## Certificate of Appropriateness

4315 W. LISBON AV. Sherman Boulevard Historic District

**Description of work** Fire damaged windows in one of the units of the apartment building at the above address.

PTS ID 100821 COA

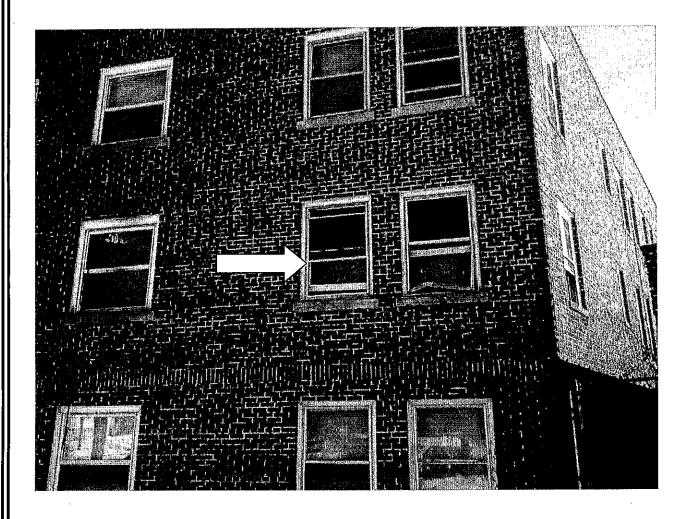
Fire damaged windows on this elevation and three on the south elevation will be replaced with wood windows

New wood windows will replace fire damaged ones in multi-unit apartment building. All wood must be painted upon completion. Please note that research has shown that if new bare wood is exposed to the exterior elements for a period of only a week or two the life expectancy of the paint job will be decreased. Glass in the windows must be clear. No low-e of tinted glass.
